**CHANGE/ERRATA**

**ISSUE NO: 1 8/94**

Title: 5100B Instruction Manual  
Part Number: 926634  
Print Date: October 1992  
Rev.- Date: 1, 1/94

Figure B.

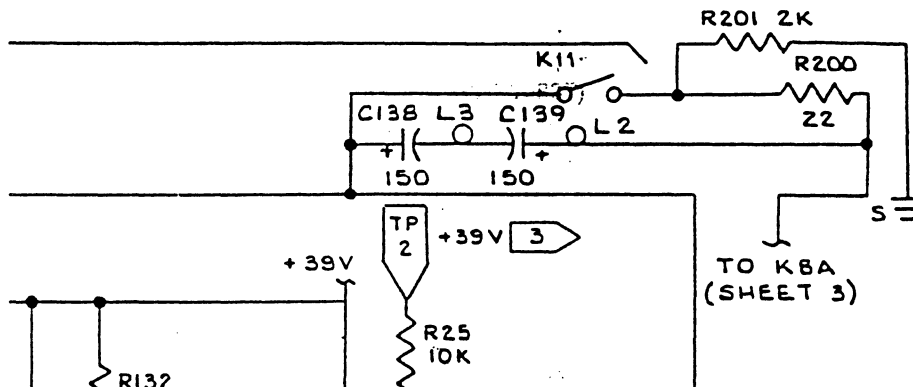
On page 7-44, Figure 7-15, add L2 and L3 as shown in Figure B:

Figure C.

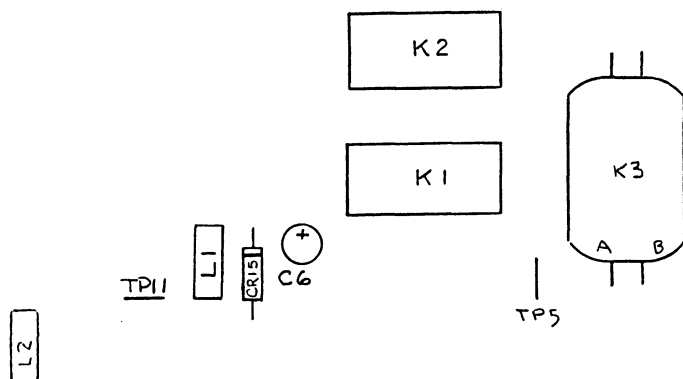
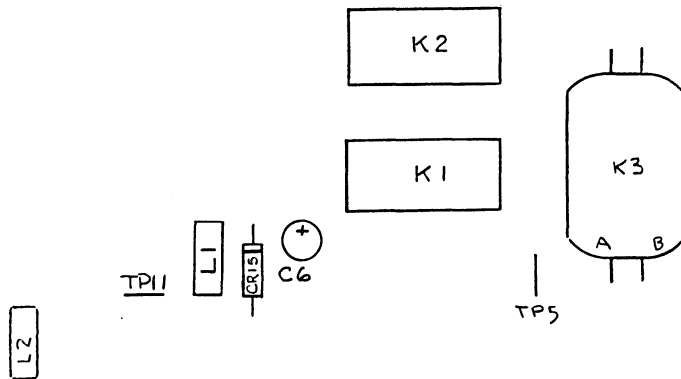
CHANGE: CR12,13/DIODE,SI,BV-75V,IO-150MA,500MW/203323/65940/1N4448/2

TO: CR12,13,15/DIODE,SI,BV-75V,IO-150MA,500MW/203323/89536/203323/3

On page 5-66 and 7-39, Figure 5-17 and 7-14, add CR15 as shown in Figure C:

Figure D.

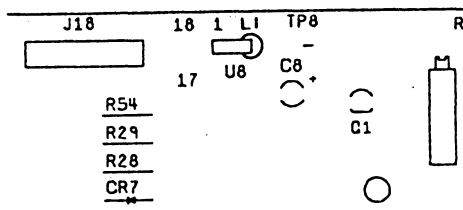
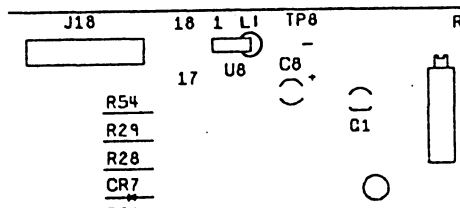
On pages 5-82, add 7-53, add L1 as shown in Figure D.

Figure E.

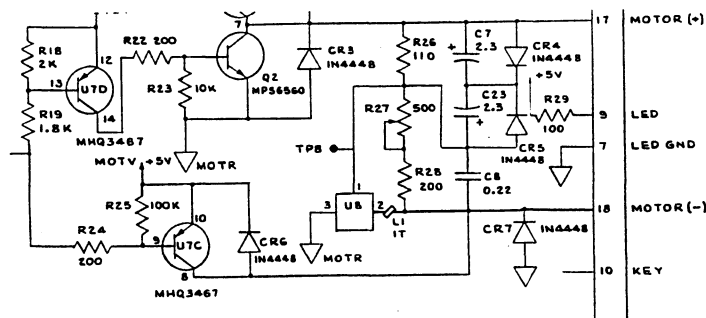
On page 7-54, add L1 as shown in Figure E.

Figure F.

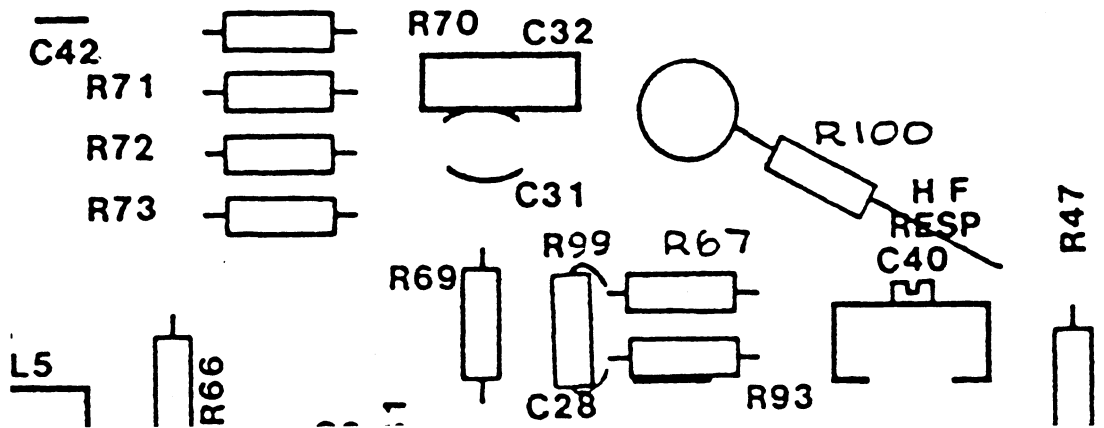
On page 603-9 and 603-18 Figures 7-10 and 7-29, add R99 and R100 shown in Figure F:

Figure G.

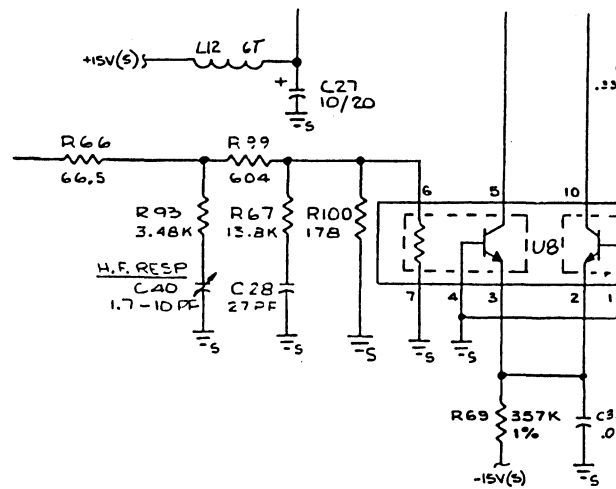
On page 7-30, Figure 7-10, add R99 and R100 as shown in Figure G:

Figure H.

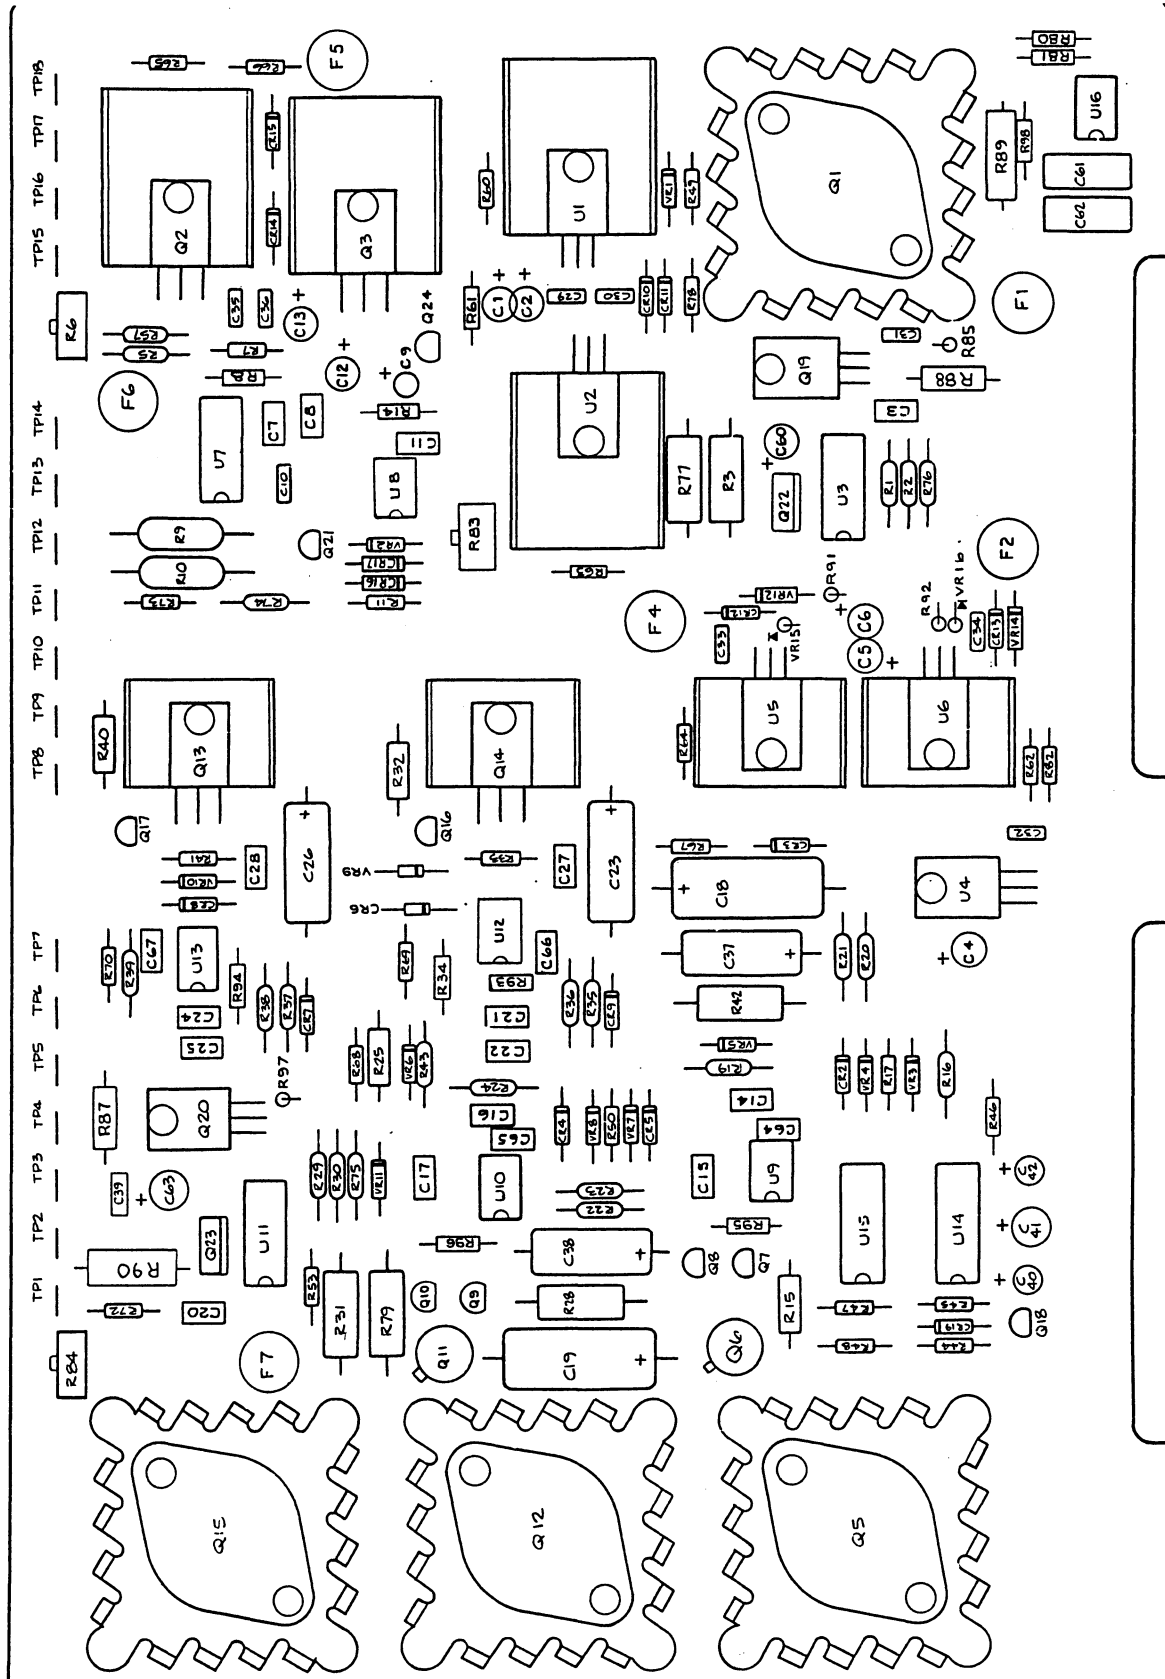
On pages 5-49 and 7-16, replace Figures 5-10 and 7-6 with Figure H.

Figure I.

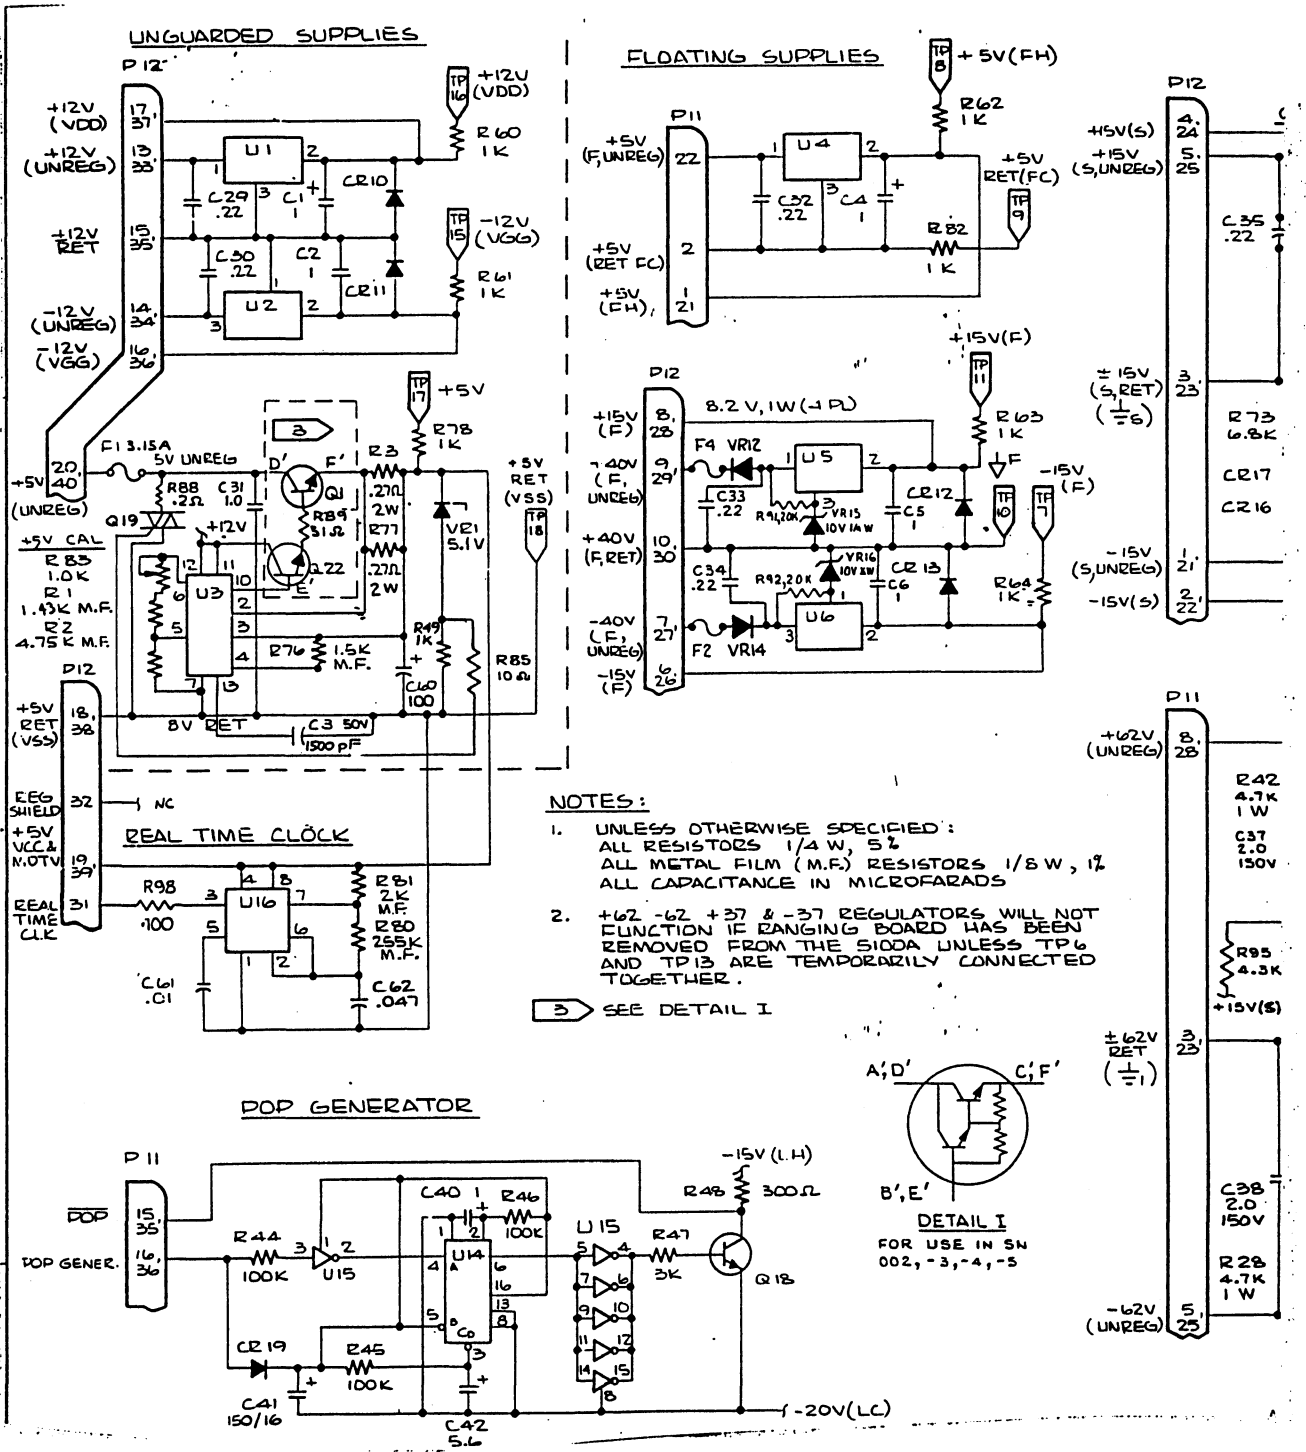
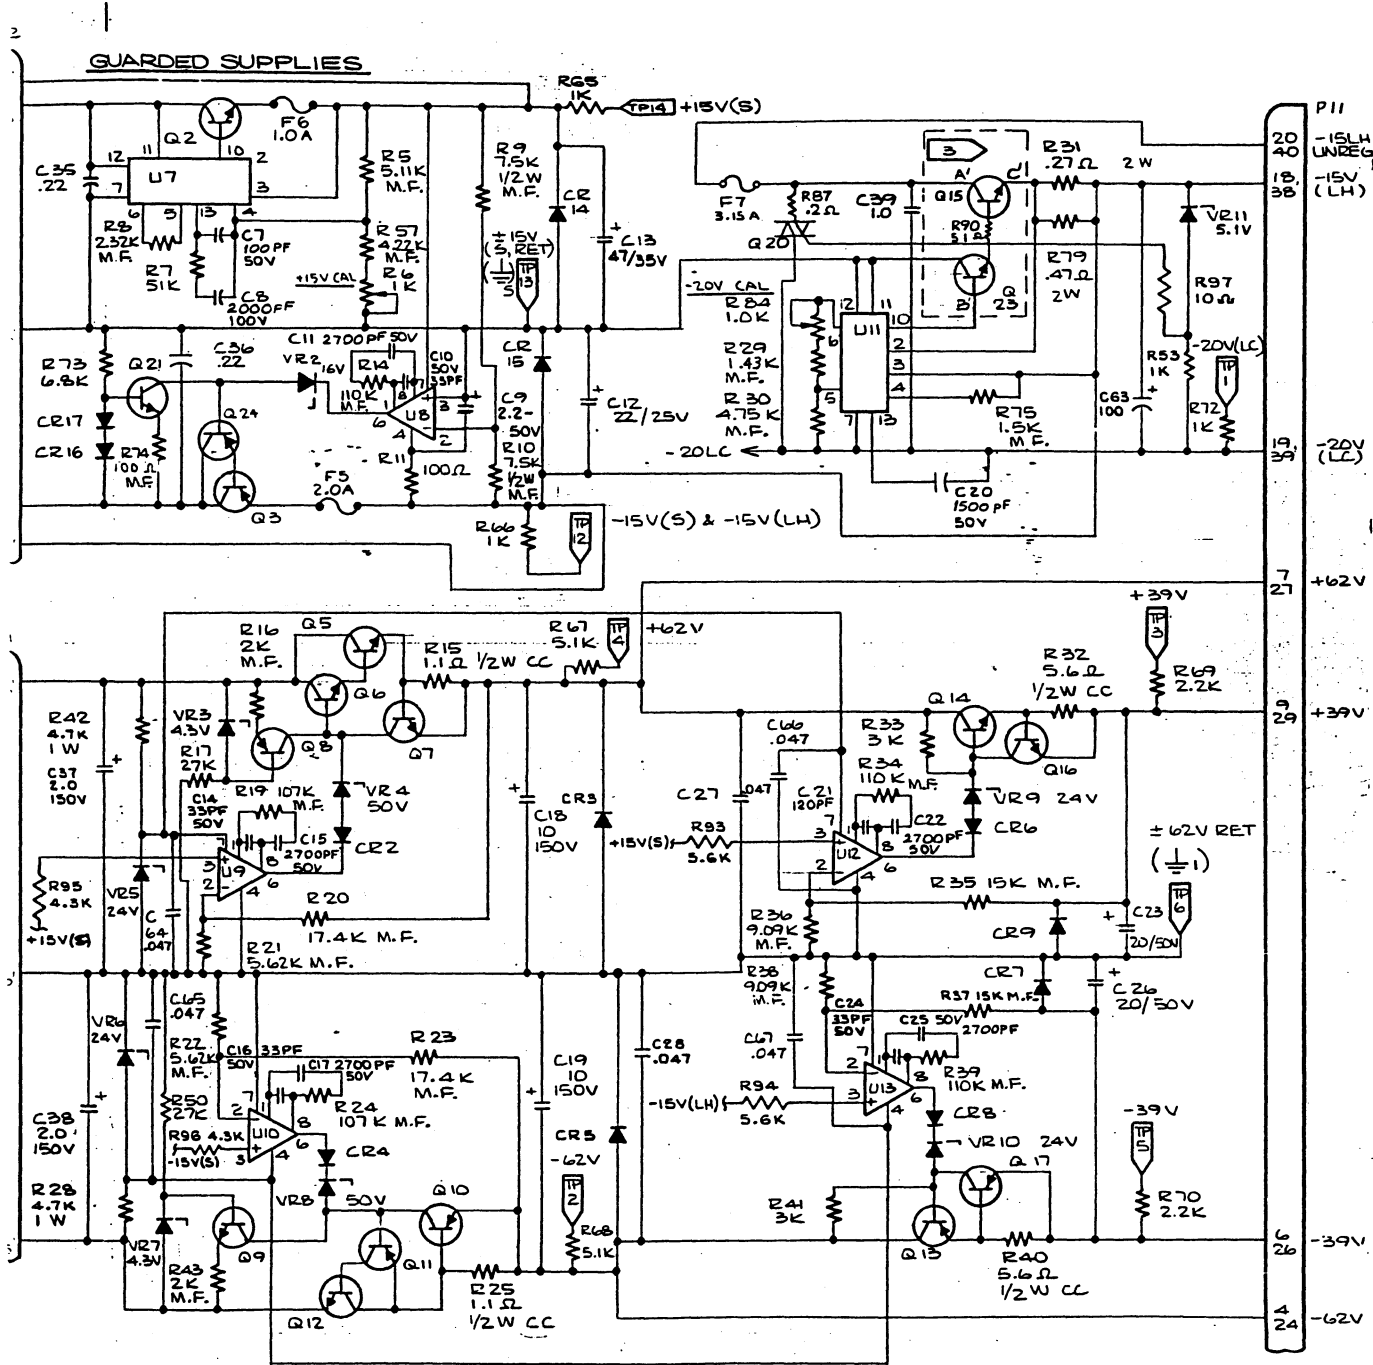
On page 7-17, replace Figure 7-6 with Figure I.
